**RE: 815 Roger Griffiths Avenue
Urban Design Brief**

In support of the Site Plan Control Application for the lands at 815 Roger Griffiths Avenue in the City of Ottawa, please find our Urban Design Brief enclosed. Per the Urban Design Brief Terms of Reference received from City staff following the pre-consultation meeting taking place May 6, 2025, alternative site plan options and responses to the urban design direction provided are included below.

Option 1

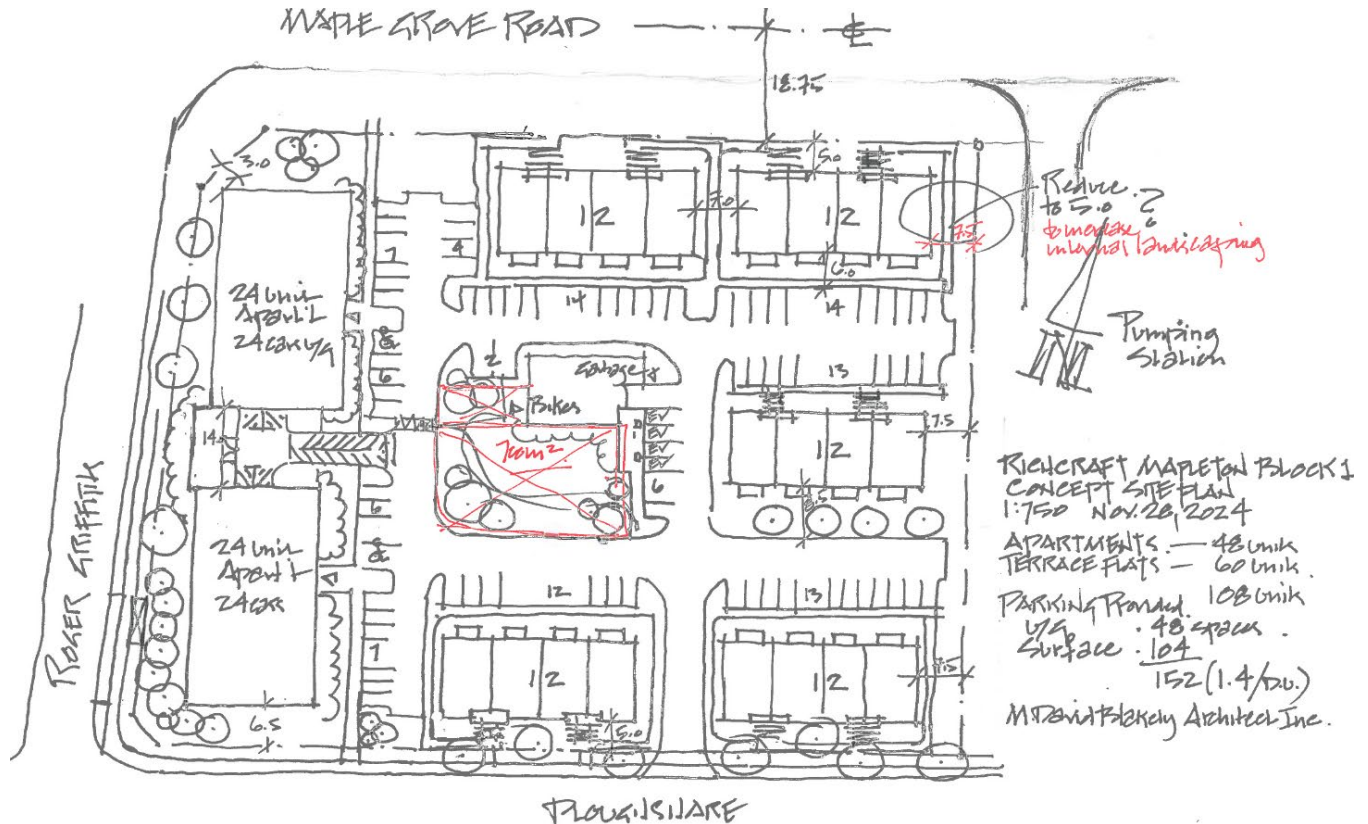
Further to the direction of City of Ottawa Urban Design Staff, examples of alternative site plan options are provided below.

Option 1 advances a concept plan for a single lot development prior to the decision to sever for a distinction between typology as well as rental and condominium. The currently proposed site plan reduces the scale of internal vehicle circulation by fully separating the accesses and locates the amenity area in an area that is more insulated from vehicles.
